May 23, 2015

01216 Version 1

HomeLink® System Has Weak or Limited Range

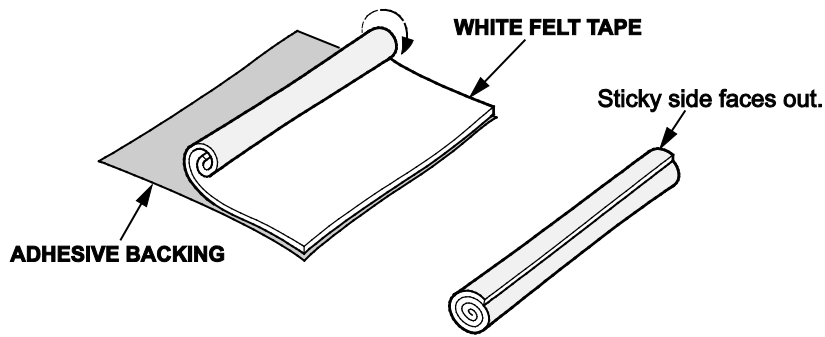
3. Cut a piece of EPT Sealer to 120mm x 65mm and wrap the entire HomeLink transceiver, then cut another piece 40mm x 70mm and wrap the end of the unit.

MDX:

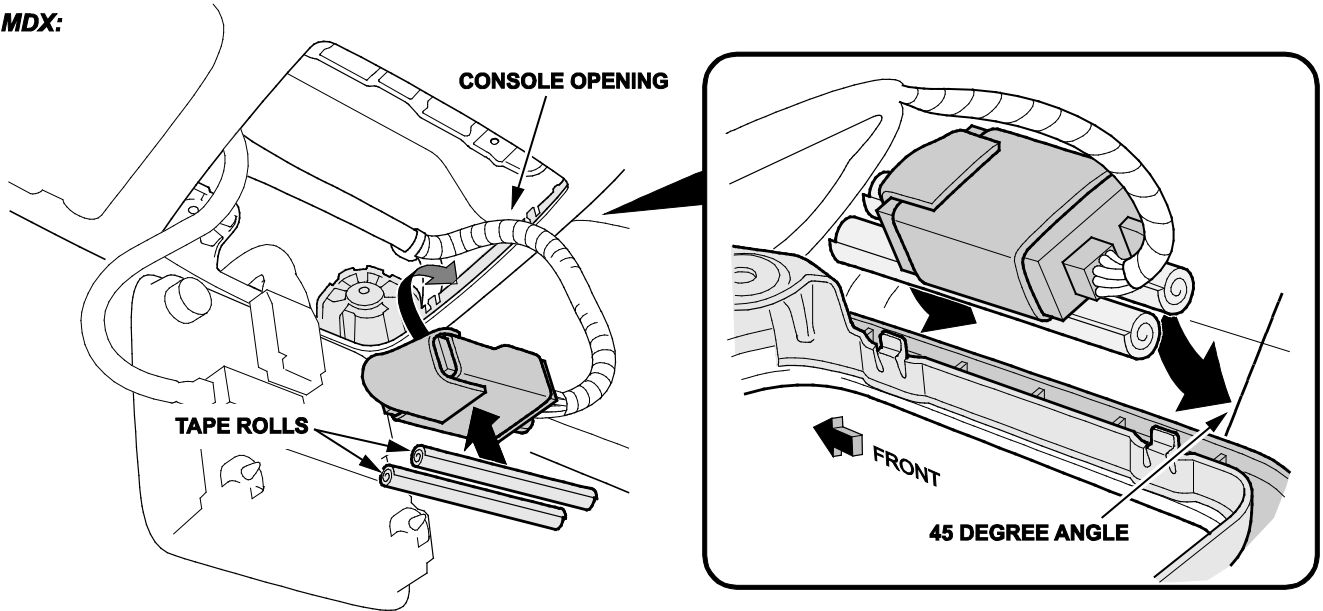
5. Stick the tape rolls to the HomeLink transceiver and stick it to the console opening at a 45 degree angle as shown.

MDX:

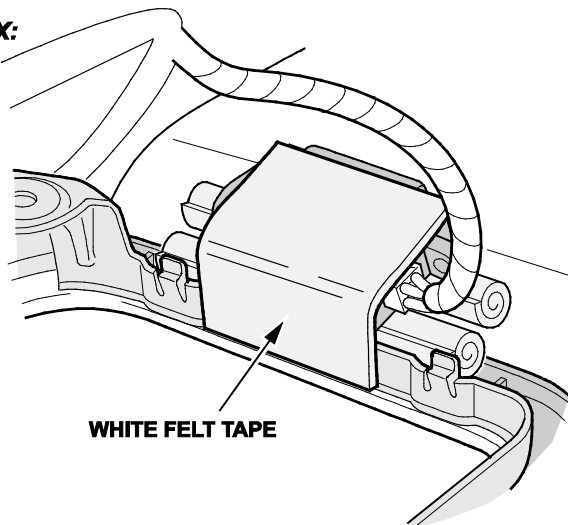
6. Secure the transceiver to the roof console with a white felt tape as shown.

RDX and RLX:

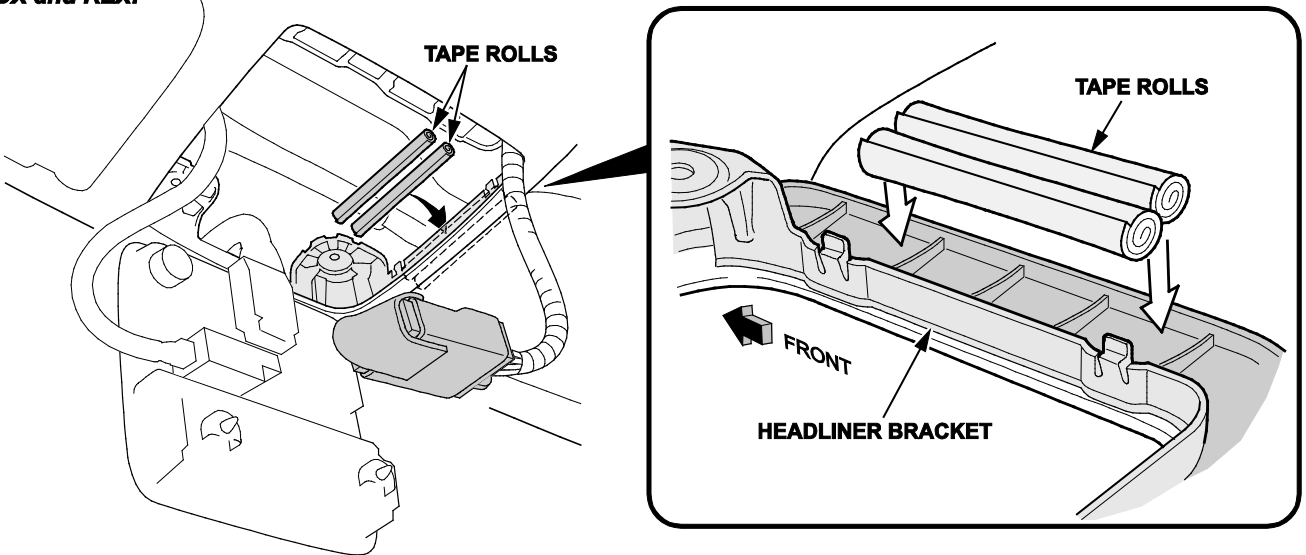
7. Stick the tape rolls to the console opening as shown.

RDX and RLX:

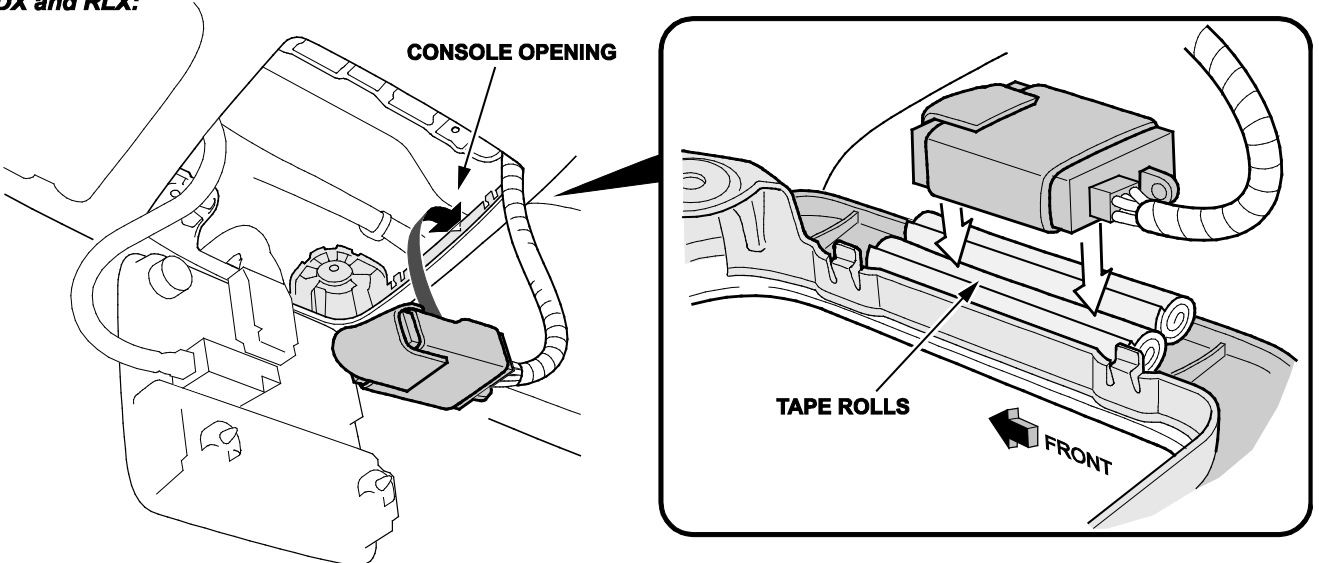
8. Stick the transceiver to the tape rolls with good pressure.

RDX and RLX:

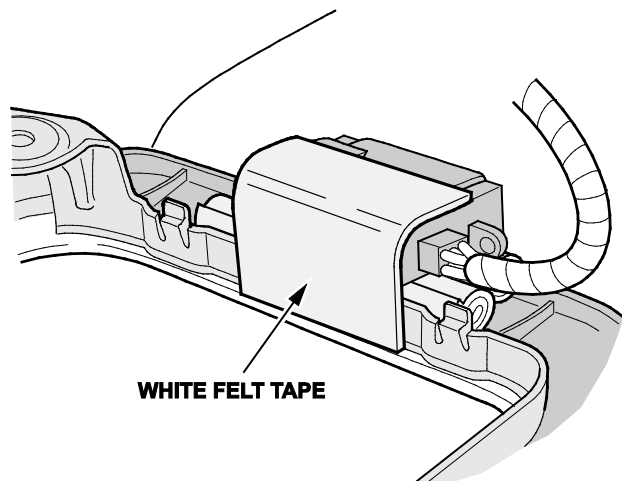
- Secure the transceiver to the roof console with a white felt tape as shown.
